# FINAL ROUND 1B TECHNICAL MEMORANDUM

for  
Middle Waterway Problem Area  
of the  
Commencement Bay Nearshore/Tideflats  
Superfund Site  
Tacoma, Washington

prepared for the:  
**Middle Waterway Action Committee**

August 23, 1999

**Figure 5**  
Middle Waterway Problem Area  
Round 1A Subsurface Samples  
And Exceedence Factors

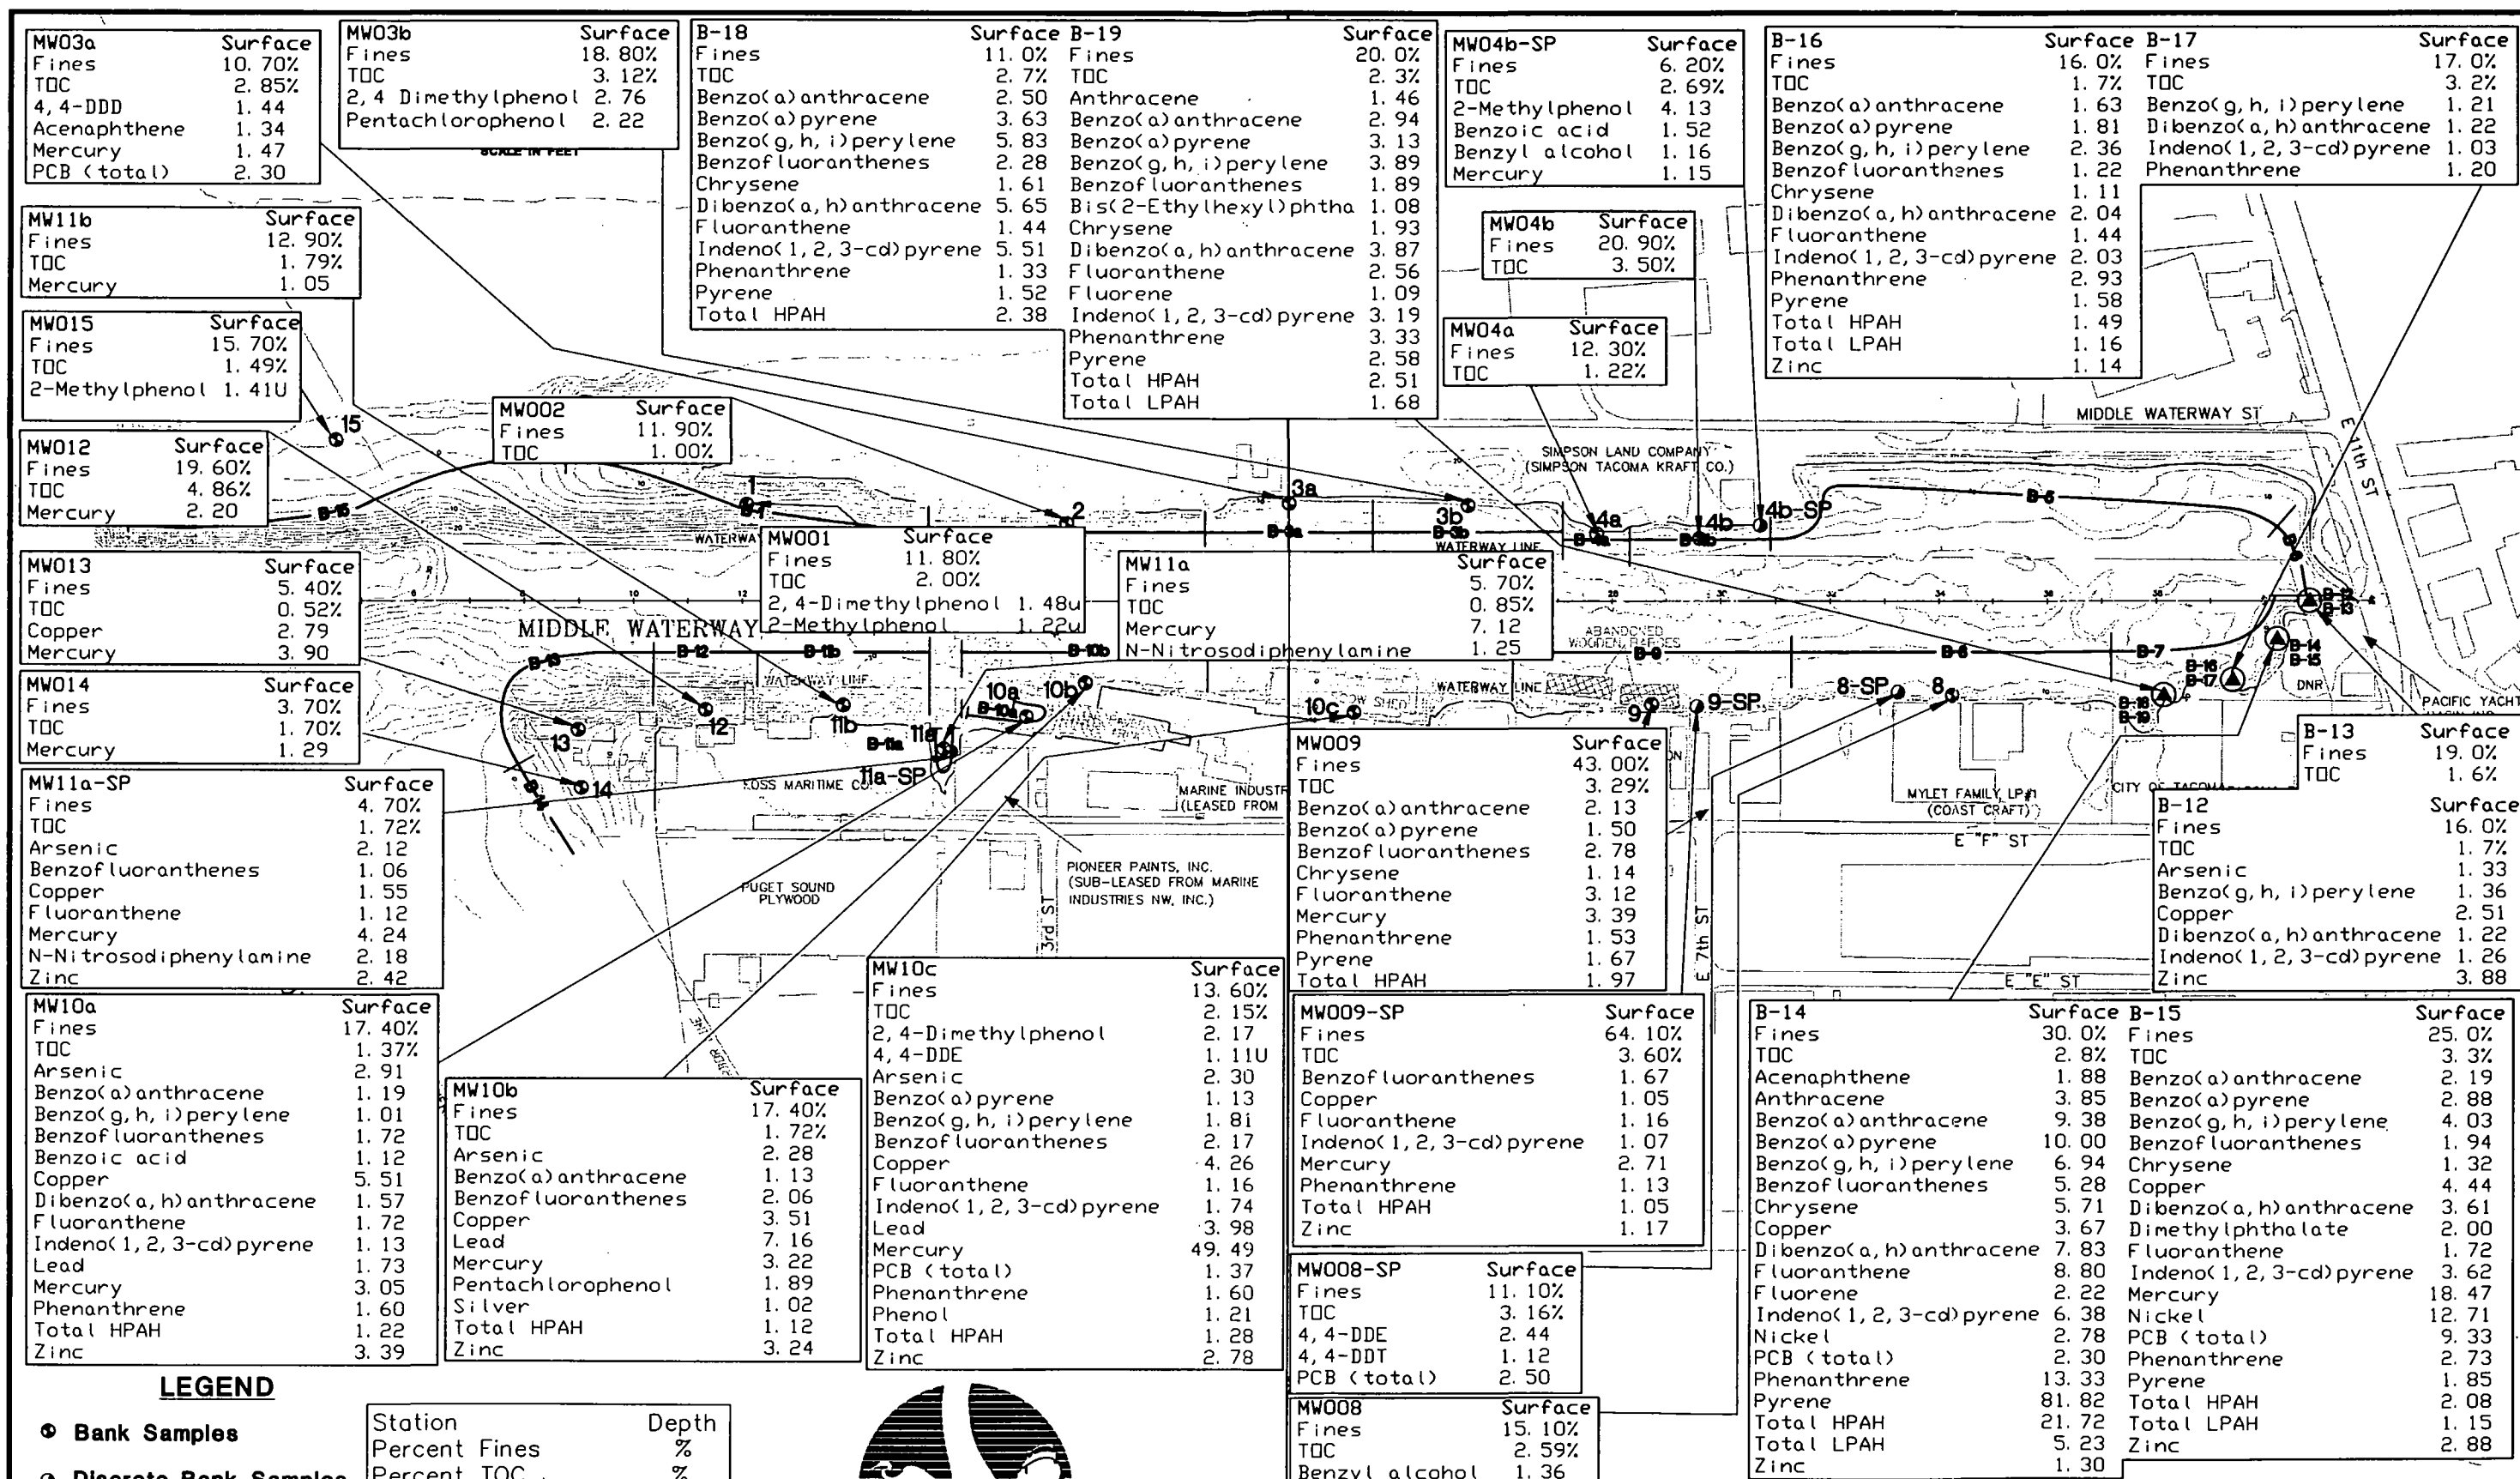
11. **Section 2.2.3, First Paragraph.** Please clarify the first sentence so that the 25 samples reported on Fig. 5 can be reconciled with the 21 locations mentioned in the text.

**Response:** The data qualifiers are defined in Tables 2 and 3. Figures 3, 4, and 5 show exceedence factors not concentrations. It is inappropriate to add qualifiers to exceedence factors as they qualify *concentrations*. Figures 3, 4, and 5 have been updated to include the undetected compounds that have detection limits greater than the SQOs. These compounds are identified by a "U" following the EF.

Figure 14  
Middle Waterway Problem Area  
Preliminary Remediation Concept

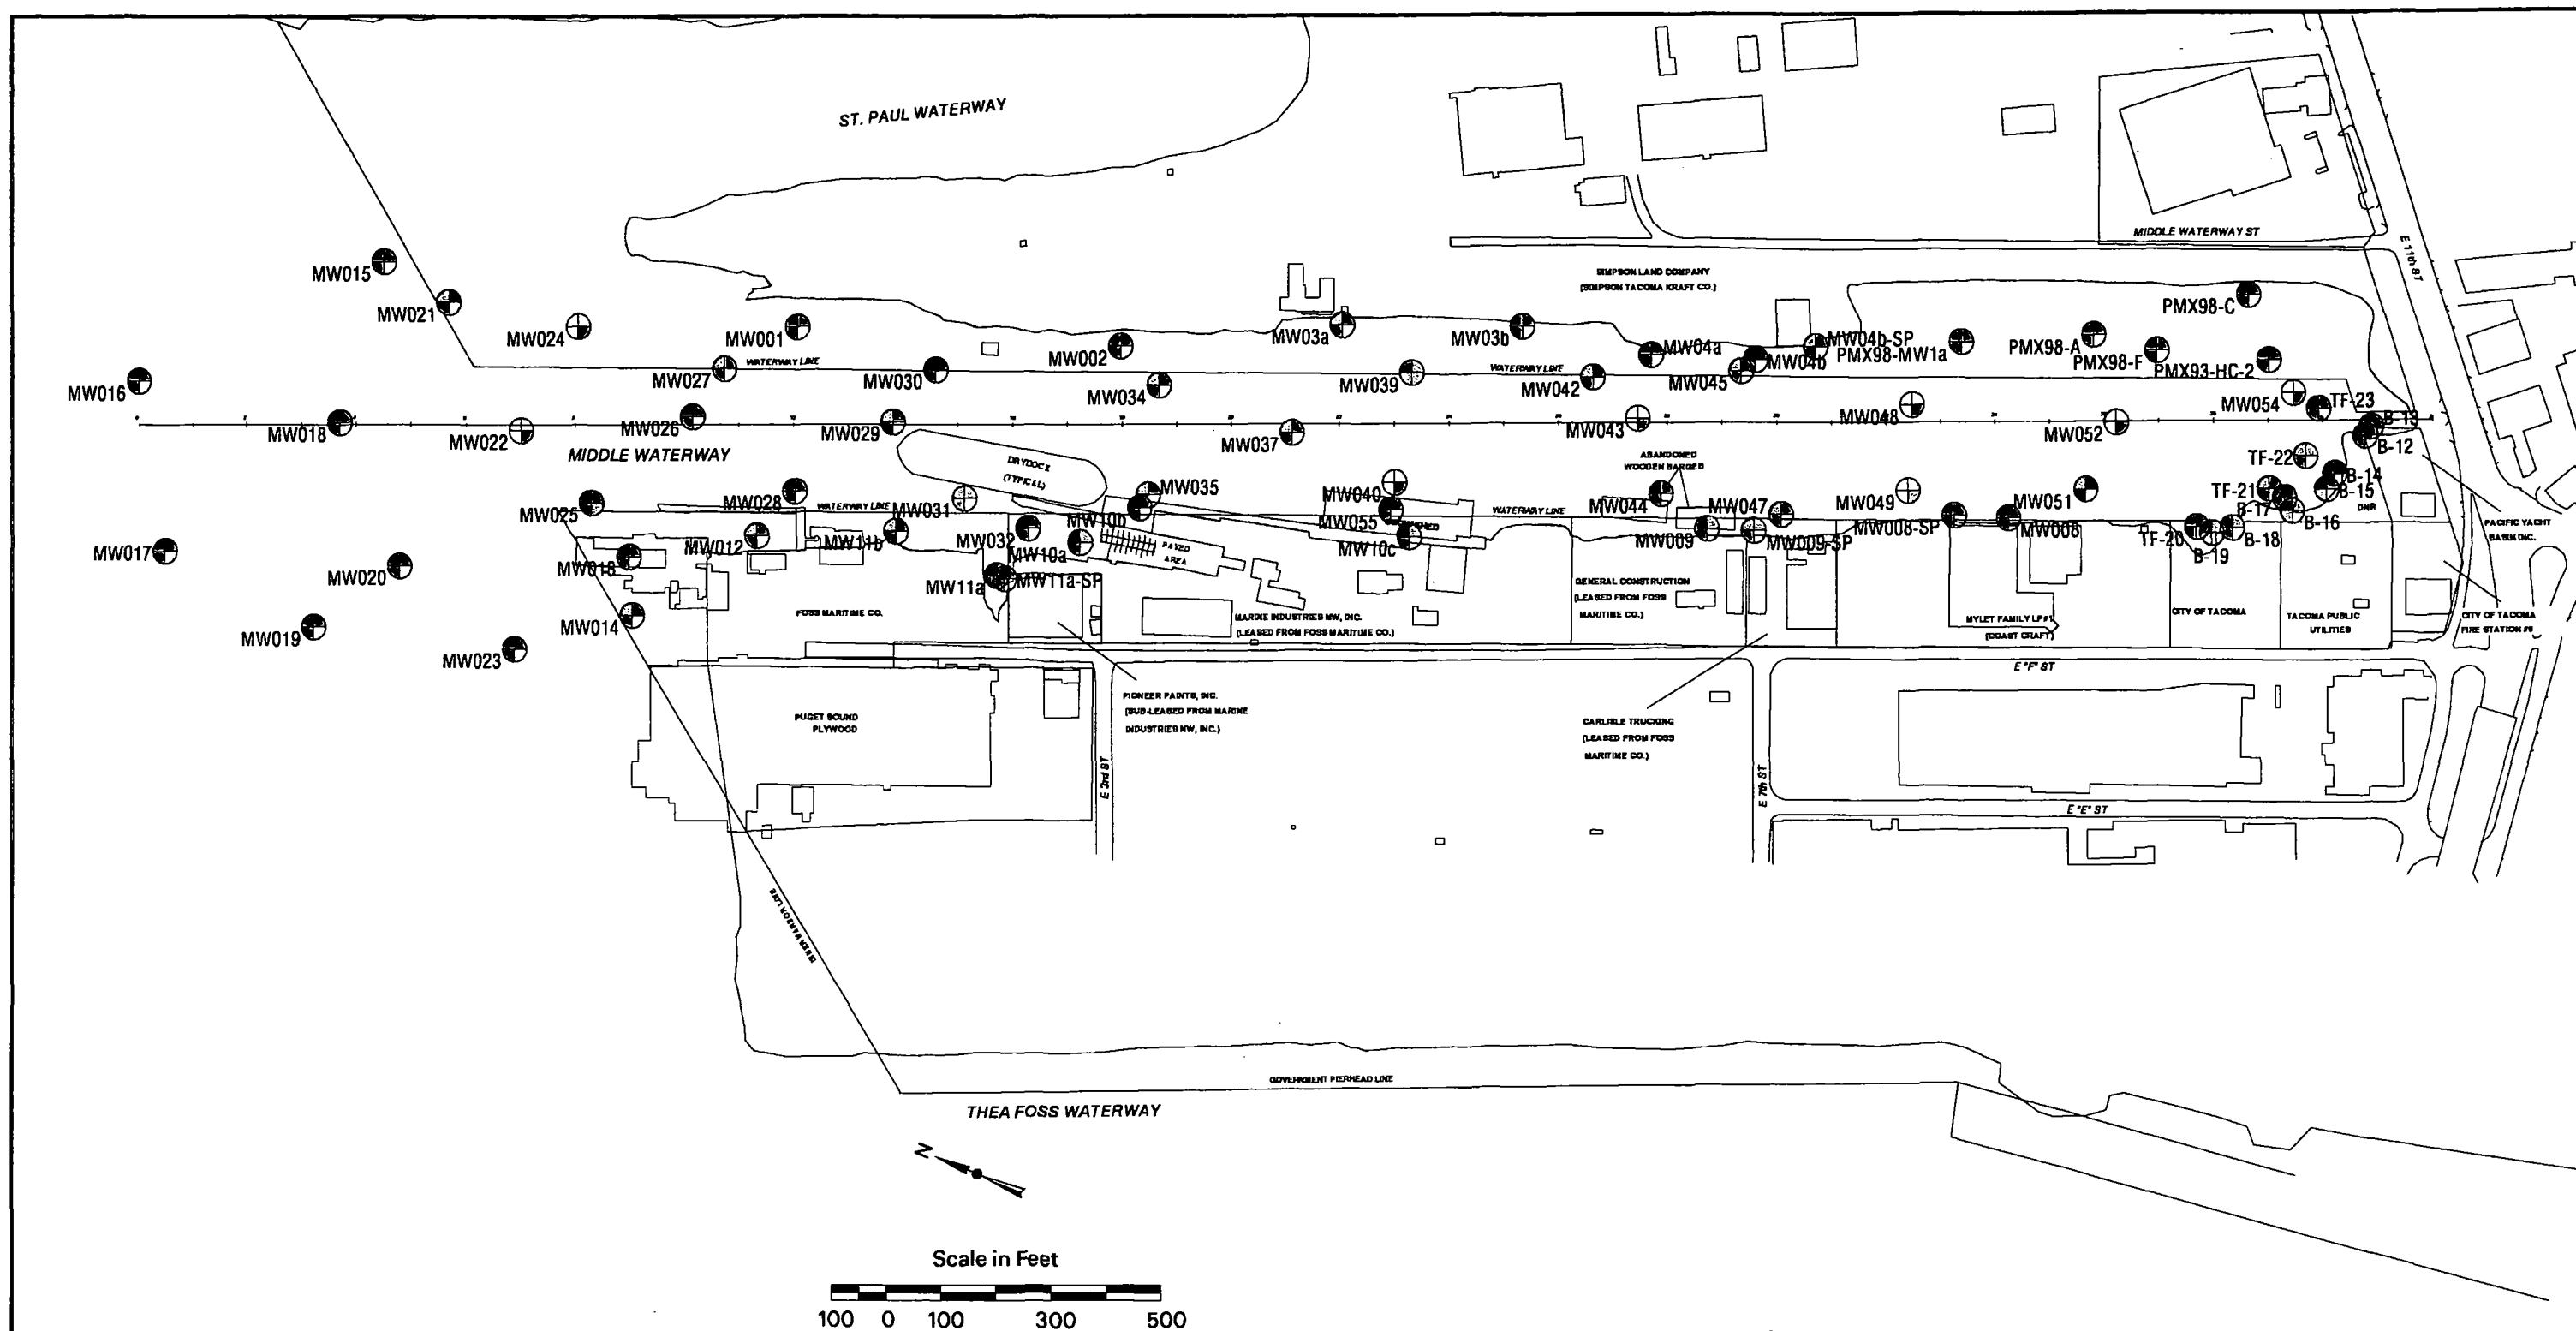
17. **Page 4-1, Section 4.2.** Figure 14 is difficult to read and should be revised/clarified so that proposed stations are distinguishable from previously sampled stations.

Please clarify figure so that proposed station MW32 (near MW029, Fig. 14) is clearly recognizable as MW132. Please explain why a gravity core sample is proposed between MW028 and MW031, but not south beyond MW035 (where diethylphthalate was found to a depth of 8 feet with an exceedance factor 5.5 times the SQO). Please justify the maximum core depth of 4 feet, although COCs were found to a depth of 8 feet.
